**Independent Review of the  
Draft Site Management Plan for the  
Mott Haven Schools Complex  
Bronx, New York**

**March 25, 2008**

One of our key recommendations was that the preparation and implementation of a Site Management Plan be robust and transparent, with the opportunity for community input. In January 2008, the SCA published a draft Site Management Plan for review by the New York State Department of Environmental Conservation (DEC), as well as for public comment. Once again NYLPI asked CPEO to conduct an independent review on behalf of its clients, the Bronx Committee for Toxic Free Schools. This time the review was funded by an emergency grant provided to NYLPI by the Mertz Gilmore Foundation. This document is CPEO's review of the draft Site Management Plan.

Figure 2: Site Plan

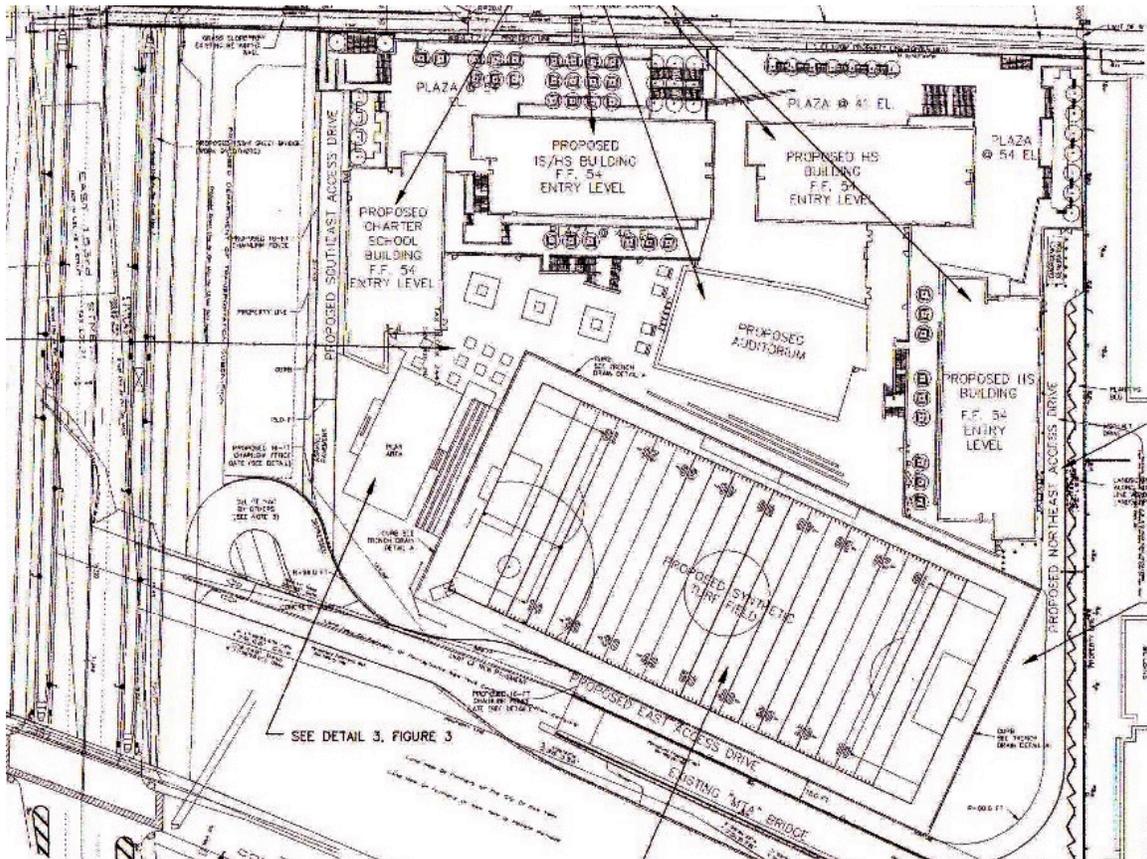
A majority of the Mott Haven campus will consist of open areas, including landscaped areas, paving, and an artificial turf athletic field. Even after excavation in the original Brownfields Cleanup Program area and five additional hotspots, as recommended in CPEO’s independent review, contaminants—primarily semi-volatile organic compounds (SVOCs)—will remain on site above the State’s Recommended Soil Cleanup Objectives (RSCOs). Thus, engineering controls are necessary, not only to prevent human contact with contaminated soil, but also to prevent flooding and other scenarios from causing the release of, and exposure to, contamination. The draft SMP proposes a Surface Cover System consisting of asphalt roads, two feet of clean fill in landscaped areas, and artificial turf made of blended polyethylene over an infill system of sand, rubber, and inert materials as protection and containment of contaminants. It also proposes restrictions on soil disturbance.

In particular, we requested, but did not receive, additional detail on the proposed artificial turf and its underlying fill. It appears from drawings in the SMP that this surface will be elevated 5 feet above the grade from the eastern roadway. If this elevation is due to the emplacement of clean fill, this would provide adequate protection from contaminants which may occur approximately 6 feet below the field. However, the drawings in the SMP do not paint a full picture. It is not clear whether this elevation occurs in the three other directions, and the SMP does not specify the depth of cover and gravel before surface soil is reached. We request that these additional drawings and information be added to the SMP, and that in any case at least two feet of clean fill—soil or gravel—be placed below the artificial turf. We also request that the SMP provide details about the permeability of the artificial turf surface.
